**Vysvetlenie informácií potrebných na vypracovanie návrhu č. 6/  
Clarification of information needed to elaboration of design no. 6**

v súťaži návrhov na predmet „Grössling“ vyhlásenom v Úradnom vestníku EÚ pod značkou 2020/S 055-130909 zo dňa 18.03.2020 a vo Vestníku verejného obstarávania č. 63/2020 zo dňa 19.03.2020 pod značkou 11697 - MNA boli vyhlasovateľovi doručené viaceré žiadosti o vysvetlenie informácií potrebných na vypracovanie návrhu:

In the design competition, for the subject „**Grössling**“ published in the Official Journal of the EU under the reference 2020/S 055-130909 of 18.03.2020 and in the Public Procurement Bulletin no. 63/2020 of 19.03.2020 under the mark 11697 - MNA, the announcer received requests for clarification of relevant information for submitting a design.

**Otázka č. 57**

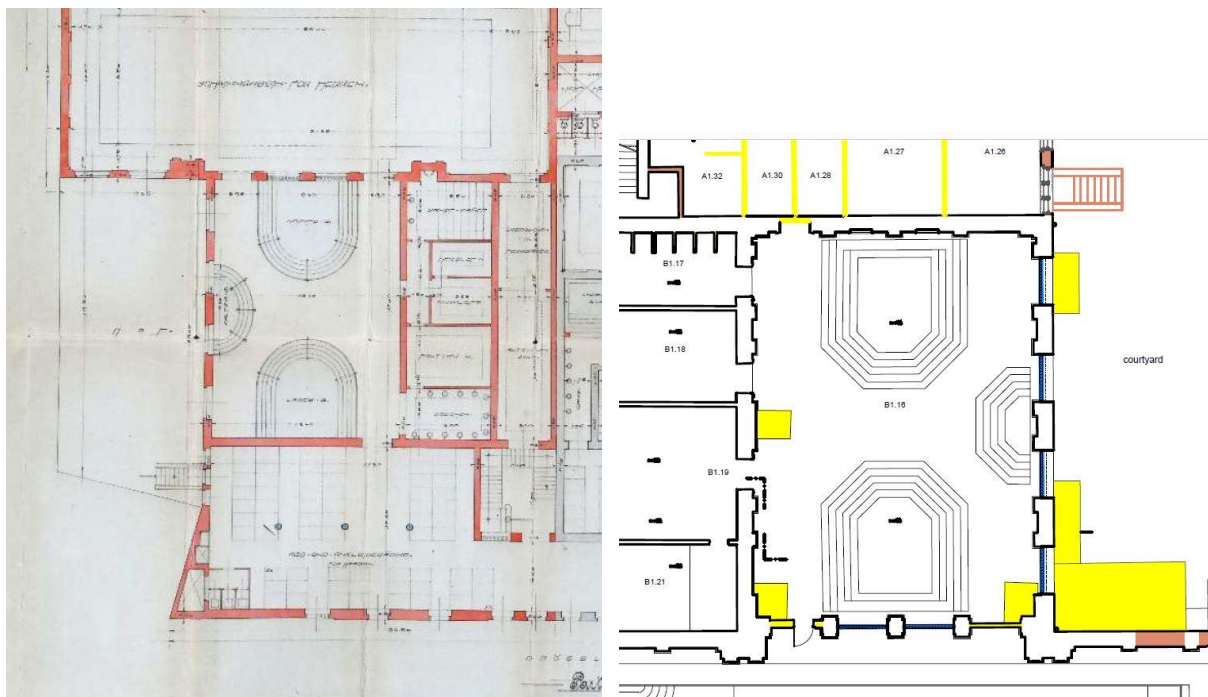
Je font písma Grossling dostupný na použitie pre súťažiacich?

Font písma Grossling je možné použiť len pre účely vypracovania súťažného návrhu. Zverejňujeme ho v systéme Josephine (Grossling-A.otf, Grossling-B.otf).

**Question no. 57**

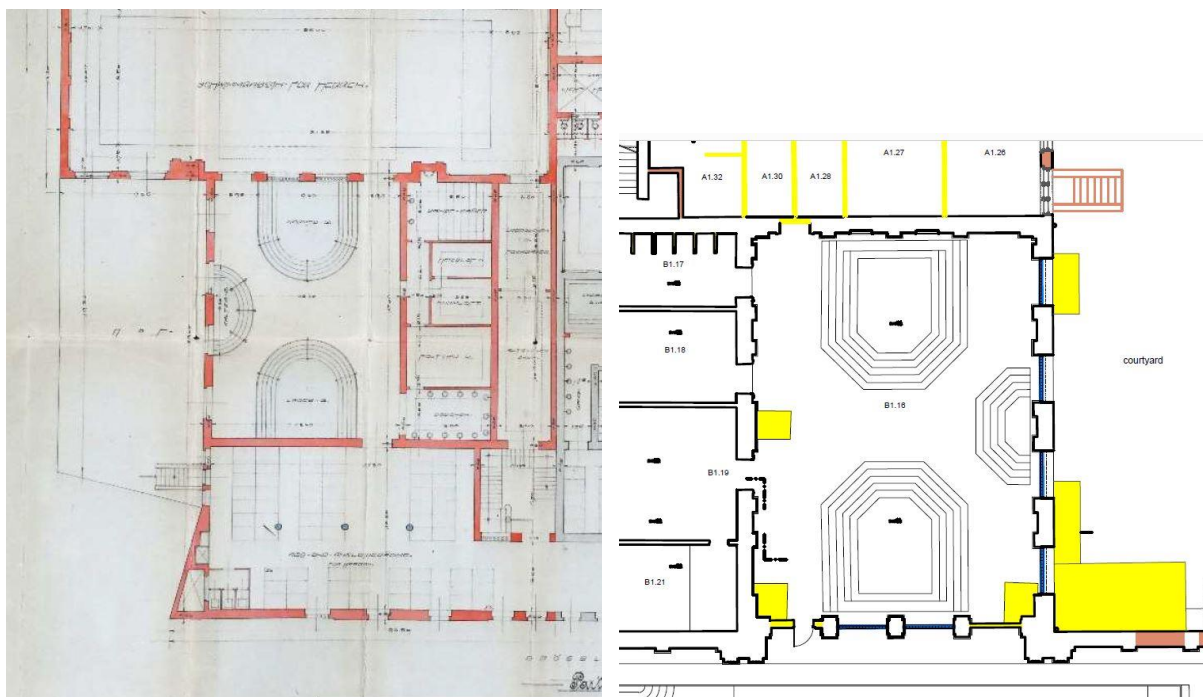
Is the Grossling font available for competitors to use?

The Grossling font may only be used for the purposes of drawing up a design contest. We publish it in the Josephine system (Grossling-A.otf, Grossling-B.otf).
